Walden Preserve 2 Filing No. 4A
Traffic Technical Memorandum
(LSC #184810)
September 7, 2018

Summary of Comments on LSC Responses to County Comments (10-19-18) WORKING FILE.pdf

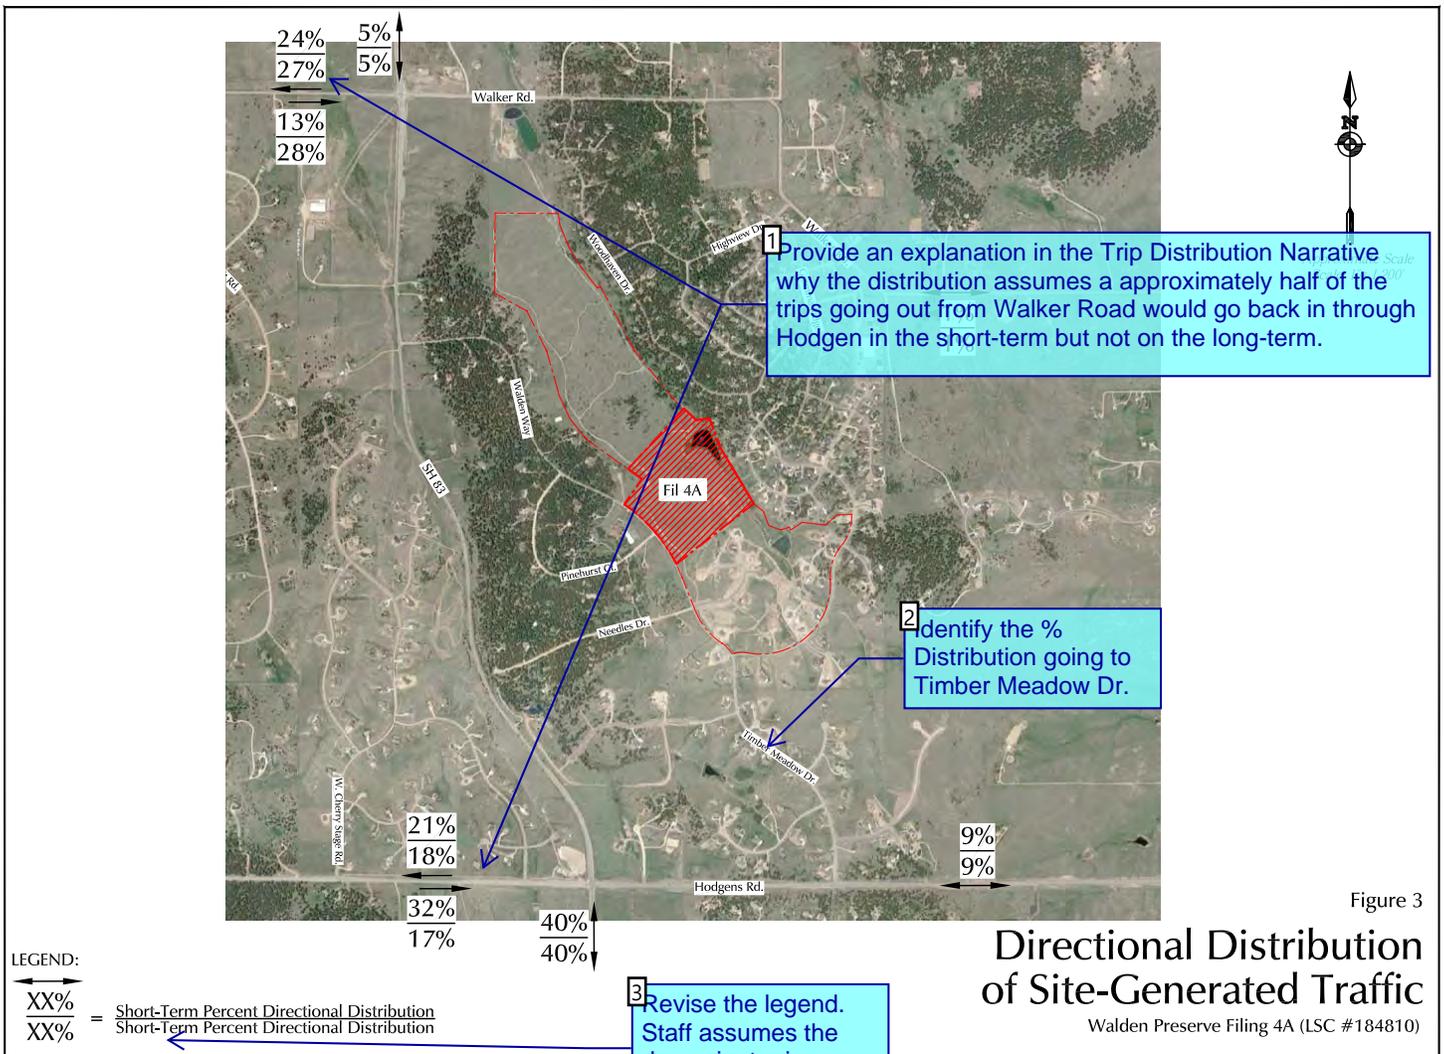
Provide an explanation in the Trip Distribution Narrative why the distribution assumes a approximately half of the trips going out from Walker Road would go back in through Hodgen in the short-term but not on the long-term.

Identify the % Distribution going to Timber Meadow Dr.

Revise the legend. Staff assumes the denominator is "Long-Term"

This figure has been removed to avoid confusion. Text has been added to clarify that the distribution from the PUD report has been used to distribute the trips in the short term.

This figure has been removed to avoid confusion. Text has been added to clarify that the distribution from the PUD report has been used to distribute the trips in the short term.

This figure has been removed to avoid confusion. Text has been added to clarify that the distribution from the PUD report has been used to distribute the trips in the short term.
